Access Compliance Report Public Rights-of-Way (Curb Ramps)

Main Street: ANTONIO_PKWY Cross Street: SWEETWATER Location: W

ADA ID: RPRK211028171327 Ramp Type: Type 1 - Perpendicular Diagonal Initial Pass/Fail: Pass Overall Compliance: No Severity Score: 21

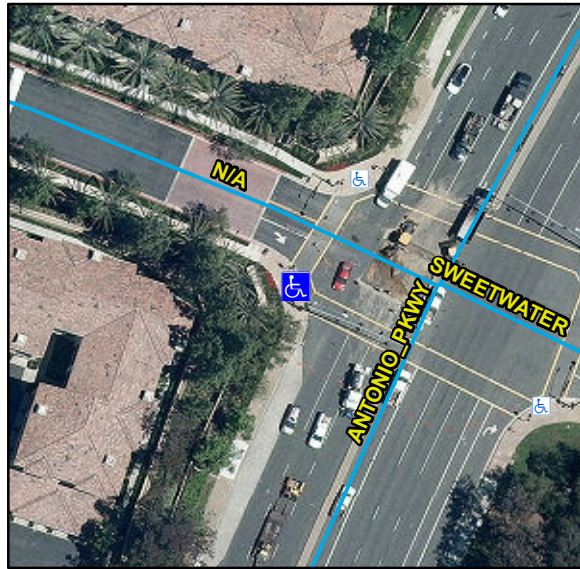
Compliance	Description	Data	Compliance	Description	Data
N/A	Ramp Length (in)	98	N/A	Flare Type LT	
Yes	Ramp Width (in)	48			Sloped
Yes	Ramp Run Slope (%)	7.1	N/A	Flare Slope LT (%)	10.2
Yes	Ramp Cross Slope (%)	1.3	N/A	Flare Traversable LT	No
N/A	Landing Present	Yes	N/A	Flare Type RT	
N/A	Landing Length (in)	36			Sloped
Yes	Landing Width (in)	48	N/A	Flare Slope RT (%)	7.6
No	Landing Run Slope (%)	2.6	N/A	Flare Traversable RT	No
Yes	Landing Cross Slope (%)	1.1	No	DWS Provided	No
N/A	Landing Movement Obstructed?	No	N/A	DWS Contrast	N/A
	Landing Movement Type	N/A	N/A	DWS Length (in)	N/A
N/A	Landing Shared	Yes	N/A	DWS Full Width	N/A
Yes	Clear Space	Yes	N/A	DWS Offset Left (in)	N/A
Yes	Clear Space To Crosswalk (in)	48	N/A	DWS Offset Right (in)	N/A
N/A	Marked Crosswalk 1	Yes	N/A	Marked Crosswalk 2	Yes
	Crossing 1 Direction	SE		Crossing 2 Direction	NE
	Marked Crosswalk 1 Width (in)	144		Marked Crosswalk 2 Width (in)	144

Yes	Ramp Inside Crosswalk 1	Yes	Yes	Ramp Inside Crosswalk 2	Yes
	Crossing 1 Slope (%)	3.3		Crossing 2 Slope (%)	8.1
	Crossing 1 Cross Slope (%)	2.6		Crossing 2 Cross Slope (%)	1.3
Yes	Gutter Ponding	No	Yes	Curb Slope	1.6
Yes	Gutter Lip Height (in)	0		Road Run Slope (%)	0.6
No	Gutter Run Slope (%)	9		Road Cross Slope (%)	0.8
Yes	Gutter Cross Slope (%)	0.1			
Yes	Overall Surface Condition: Acceptable		Yes	Perp Joint Present	Yes
	Cross Gutter Present?	No		Spandrel Present?	No
	Replace Cross Gutter?	N/A		Replace Spandrel?	N/A

Remove & Replace Curb Ramp With Two New Directional Ramps or Equivalent. Remove & Replace Gutter.

R304.2.1, R304.2.2-Perp, R304.3.2-Para, R305, R304.5.4, STD 1115
